Hocutt-Ellington Library Renovation

Bid # 700-ENG-2025-12

Addendum No. 03

A610

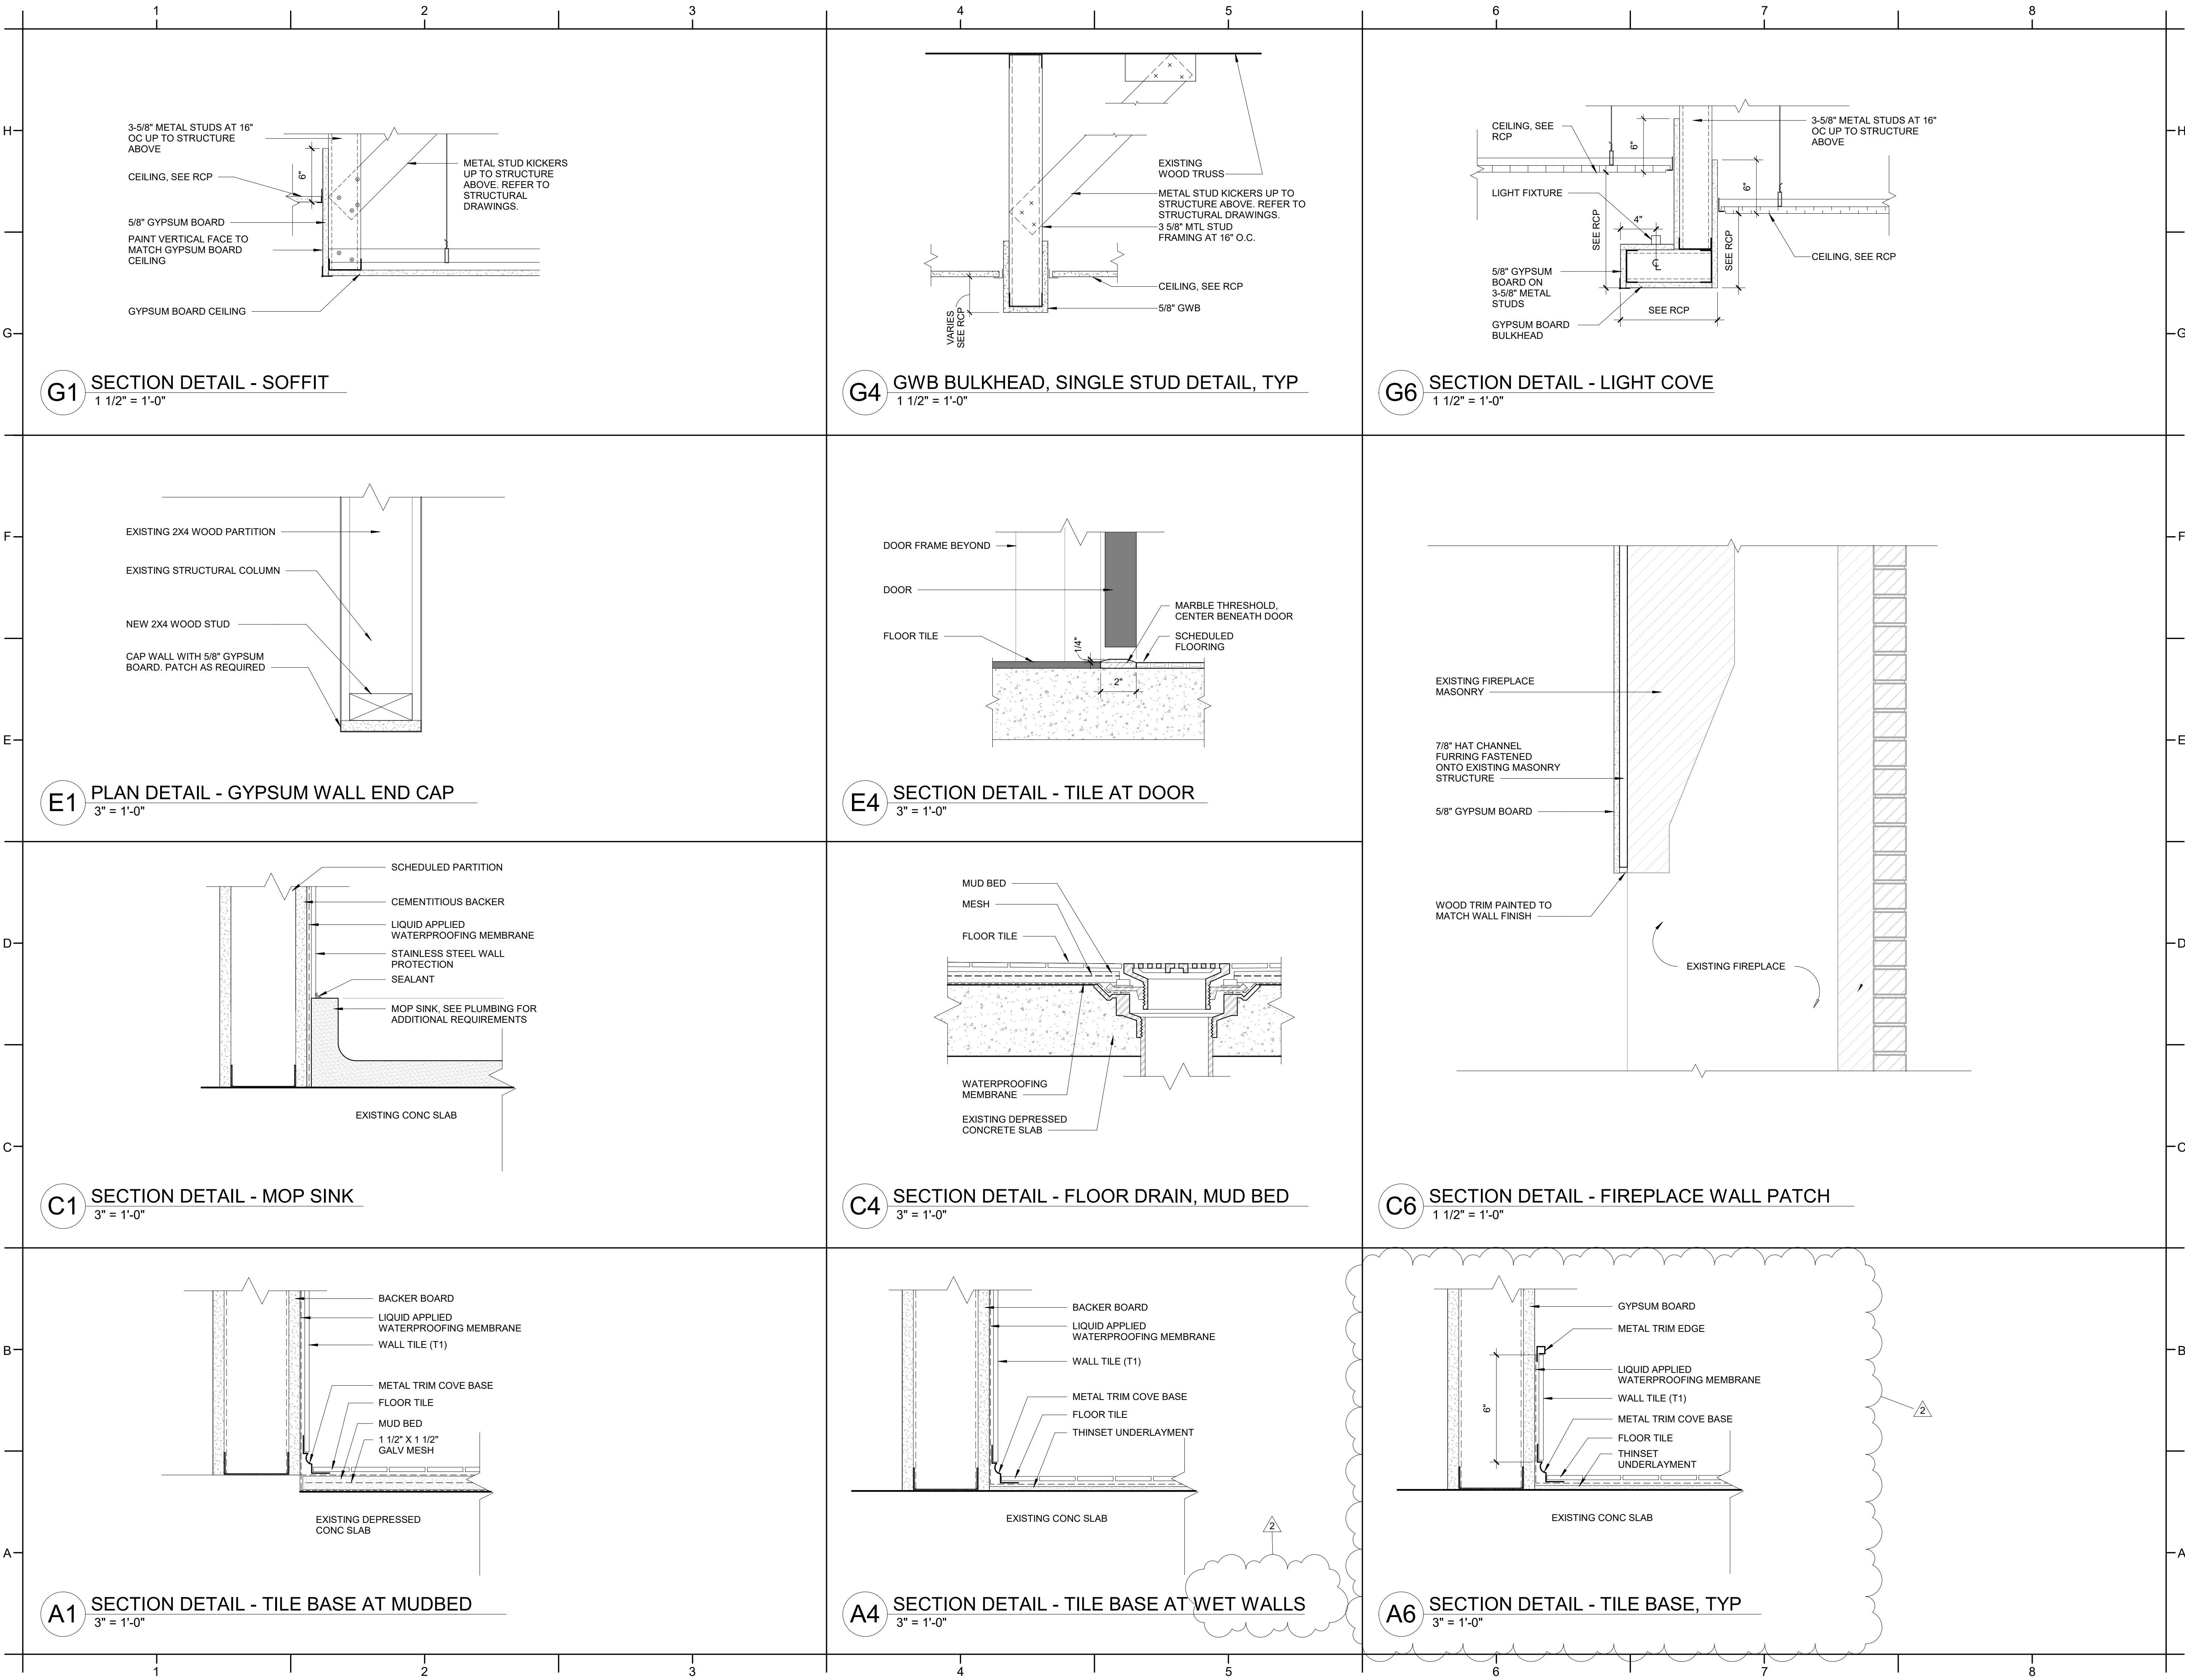
1. Sheet A610
 - a. Added detail A6 to indicate the floor base treatment in restrooms for walls that do not have tile.
